**OBJECTION TO THE OBERON WHITE GRANITE QUARRY (APPLICATION 07\_0122)**

# Oberon White Granite Quarry Review of EAR

Oberon White Granite Quarry  
Ferndale Road

Submitted to  
Department of Planning  
On Behalf of Lawndock Pty Ltd

Figure 1 – Map Showing View Analysis Locations (map extracted from Figure 1.2 of EAR)

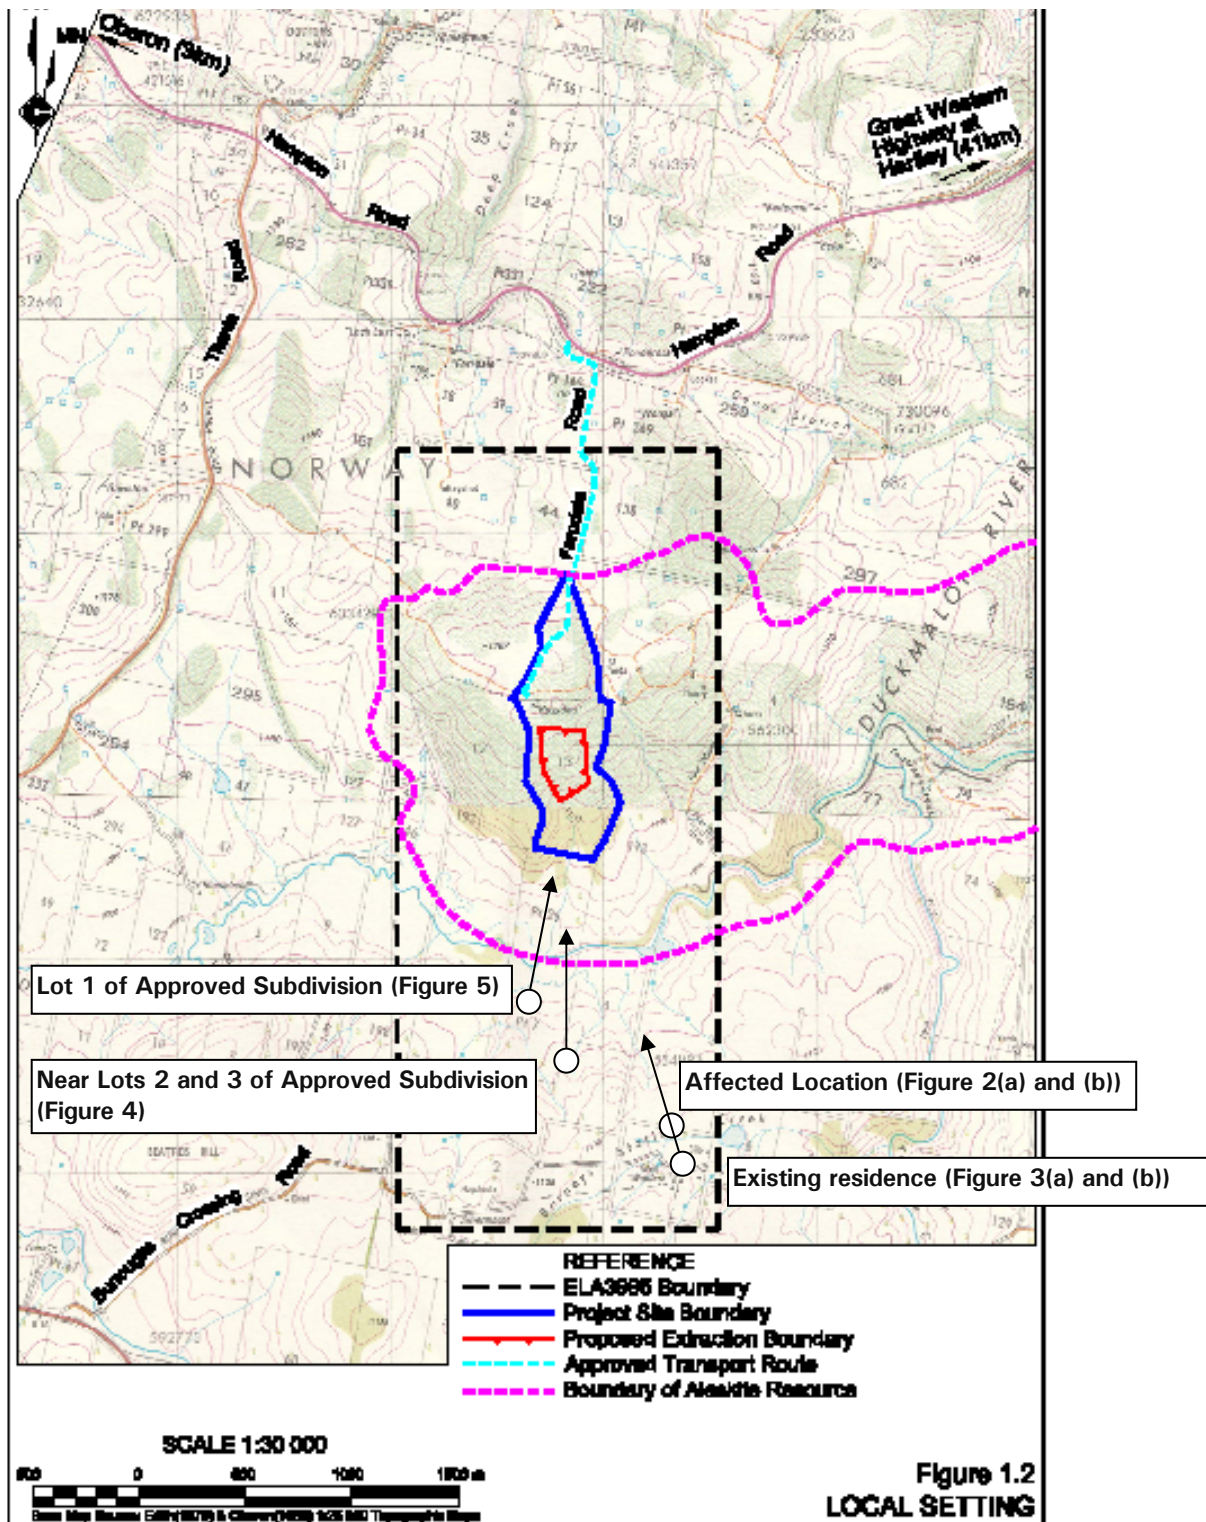
We have carried out a preliminary view analysis to estimate the level of impact. It is considered that a more detailed and robust visual impact assessment should be carried out by the proponent to properly determine the likely level of visual impact to Lawndock.
